Exhibit F2-2-3 Attachment 1

### Assessment of Pickering Enhanced Operations (IESO evidence)

from: Environmental Defence Compendium for Panel 3A, Page 3

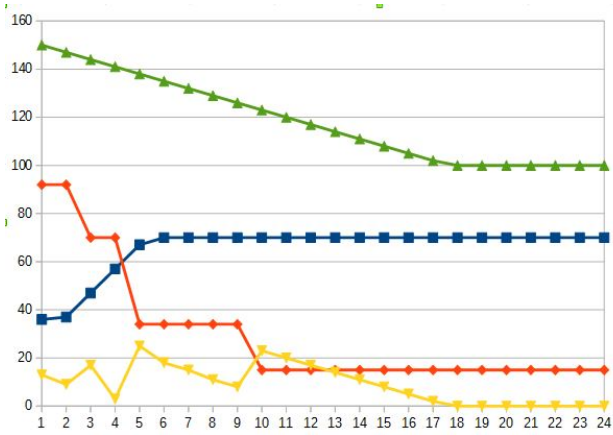
**Question:** Are these values reasonable for this cost comparison?

**Question:** Are the existing gas/oil-fired generators capable of delivering the required amount of power during the Pickering extension period?

**Question:** Considering the high cost of the Pickering power is there an alternative, such as imported power, that might be feasible and potentially less expensive?

**Question:** Does 8.73 cents/kWh represent the historic cost of Pickering power or the incremental cost of the power produced during the extension period?

**Right:** Adding the electrical energy produced during the Pickering extension to the previous graph provides more time to adapt via demand reductions and new generation sources but the timing calls for substantial use of natural gas peaking power.

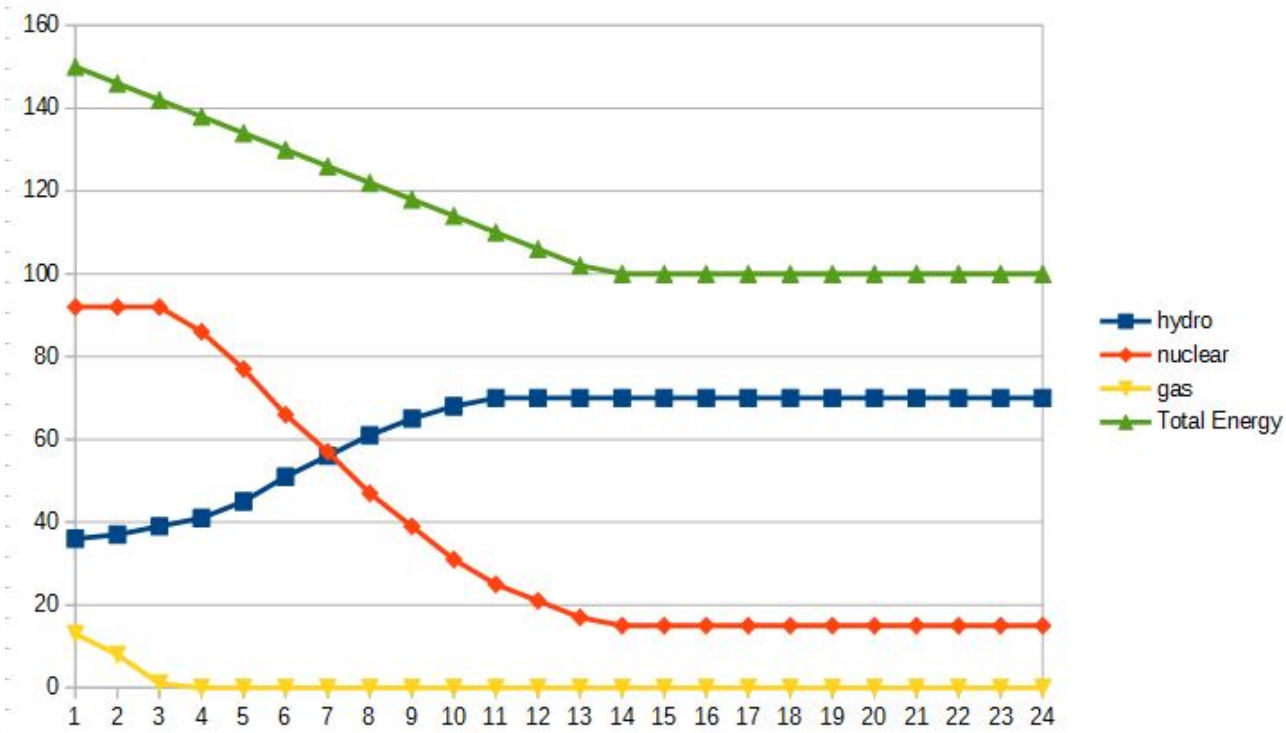
**Above:** If the reactors are shut down in a sequence that produces a smoother plot for the nuclear contribution then the need for the gas-fired generation falls to zero in the coming two years and remains at that value until 2040 providing the LTEP produces demand reductions (Green line) and generation increases (Blue line). Two reactors (Darlington 2 and Bruce 4) are assumed to remain in operation.

**Caveat:** The values shown in the graph include wind turbine generation (9.3 TWh growing to 15 TWh) but that contribution is not plotted.

**Question:** Given the emphasis put on conservation and other demand reduction measures by the IESO and the Energy Ministry is it reasonable to expect that the result will be substantial reductions in demand (the green line)?

**Question:** Will these reductions result in large part from reductions in power that is used for thermal applications, such as space heating and cooling and DHW?

**Question:** Are the big demand peaks that occur in the summer and the winter primarily caused by the demand caused by thermal loads?

**Question:** If the thermal demand peaks are flattened by employing better building insulation, using GSHP's or by exergy storage what effect will that have on the need for peaking power?

Plot of Supply and Demand based on:

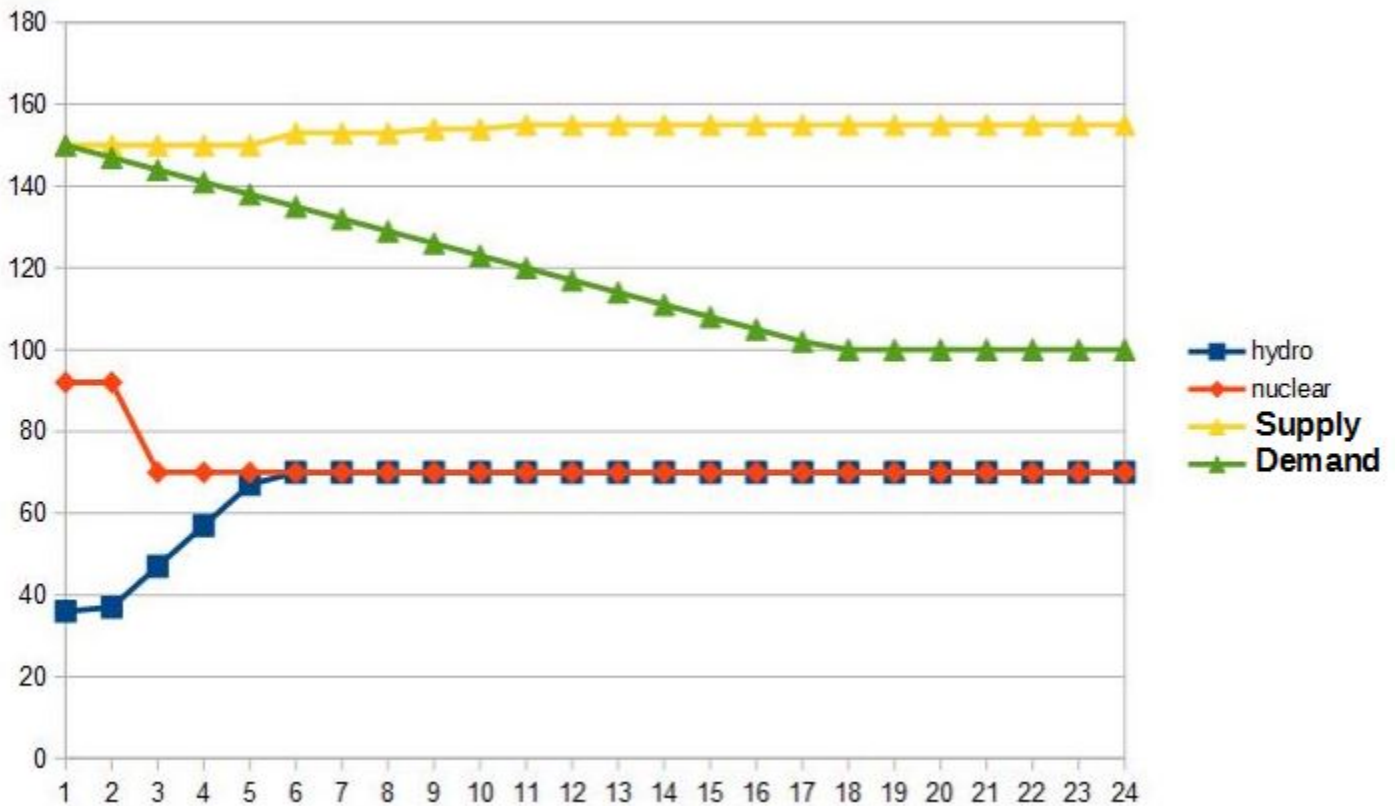
**Question:** Is there a potential for reducing the demand by reductions in non-thermal electricity like lighting and appliance/machinery efficiencies?

**Question:** Is there also a potential for increasing the electricity supply by using generation that does not generate GHG, such as enhanced hydro generation (made possible by incorporating pumped hydro or other storage methods like exergy storage), or by wind and solar power generation?

**Question:** Are there any physical obstructions to achieving substantial demand reductions and supply enhancements as shown in the graph?

**Question:** Does the IESO expect that the future cost of wind and solar power will be competitive with the 8.73 cents per kWh for Pickering electricity?

**Question:** If the hydro generation is increased by utilizing storage provided at the consumer end of the supply chain that increase could be achieved with the existing hydro facilities with no changes in the river flow or damming, but that might call for increased turbine capacities. Has the IESO carried out a study on those costs?

**Question:** I assume that you agree that in power grids the supply must match the demand?

**Question:** How does the IESO propose to achieve that supply/demand balance if the supply grossly exceeds the demand?

**Question:** If production needs to be curtailed which cutbacks would be preferable:

- (a) to OPG or IESO
- (b) to ratepayers

**Question:** If the LTEP is successful in achieving its top objective (conservation/demand reduction) and there is no reduction in supply how will it ever be possible to achieve any balance in supply and demand irrespective of the magnitude of the supply and demand improvements?
